Form 3160-5  
(June 2019)UNITED STATES  
DEPARTMENT OF THE INTERIOR  
BUREAU OF LAND MANAGEMENTFORM APPROVED  
OMB No. 1004-0137  
Expires: October 31, 2021**SUNDRY NOTICES AND REPORTS ON WELLS**  
**Do not use this form for proposals to drill or to re-enter an abandoned well. Use Form 3160-3 (APD) for such proposals.**

8. Well Name and No. ANTERO 14 FED COM/507H

9. API Well No. 30-025-50660

EOG respectfully requests an amendment to our approved APD for this well to reflect the following changes:

## WELL LOCATION AND ACREAGE DEDICATION PLAT

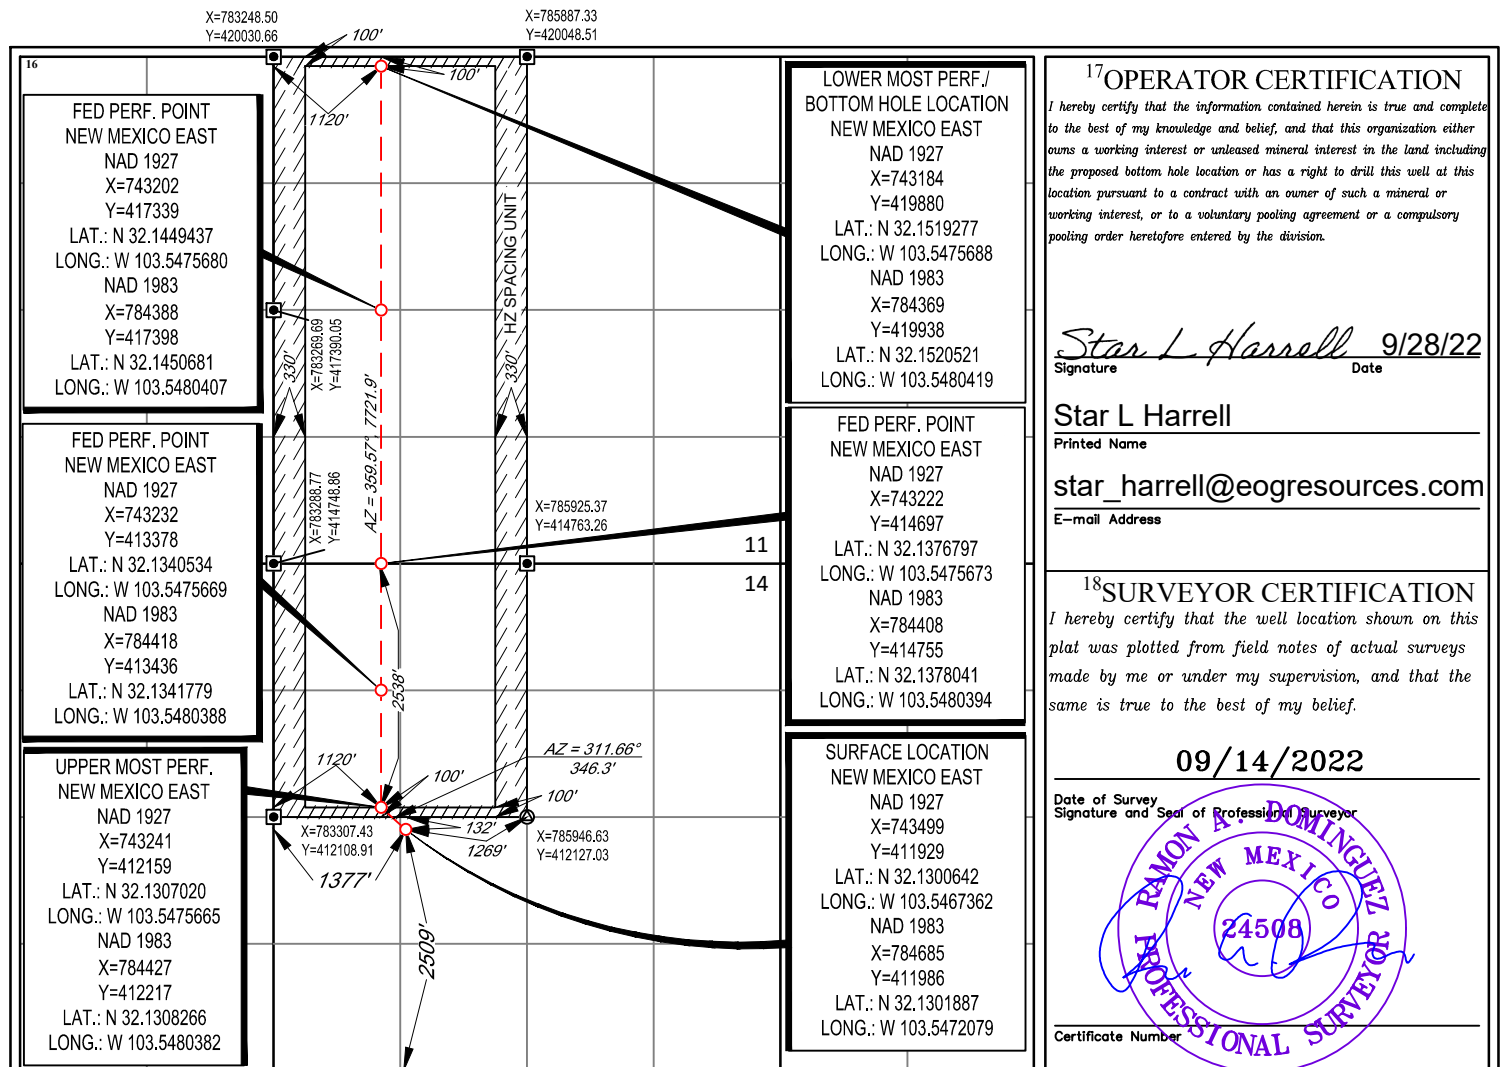
Change SHL from T-25-S, R-33-E, Sec 14, 2069' FNL, 1464' FEL, Lea Co., NM, to T-25-S, R-33-E, Sec 14, 2509' FSL, 1377' FWL, Lea Co., N.M.

Change BHL from T-25-S, R-33-E, Sec 11, 100' FNL, 2178' FEL, Lea Co., NM, to T-25-S, R-33-E, Sec 11, 100' FNL, 1120' FWL, Lea Co., N.M.

| UL or lot no. | Section   | Township    | Range       | Lot Idn  | Feet from the | North/South line | Feet from the | East/West line | County     |
|---------------|-----------|-------------|-------------|----------|---------------|------------------|---------------|----------------|------------|
| <b>K</b>      | <b>14</b> | <b>25-S</b> | <b>33-E</b> | <b>-</b> | <b>2509'</b>  | <b>SOUTH</b>     | <b>1377'</b>  | <b>WEST</b>    | <b>LEA</b> |

| UL or lot no. | Section   | Township    | Range       | Lot Idn  | Feet from the | North/South line | Feet from the | East/West line | County     |
|---------------|-----------|-------------|-------------|----------|---------------|------------------|---------------|----------------|------------|
| <b>D</b>      | <b>11</b> | <b>25-S</b> | <b>33-E</b> | <b>-</b> | <b>100'</b>   | <b>NORTH</b>     | <b>1120'</b>  | <b>WEST</b>    | <b>LEA</b> |
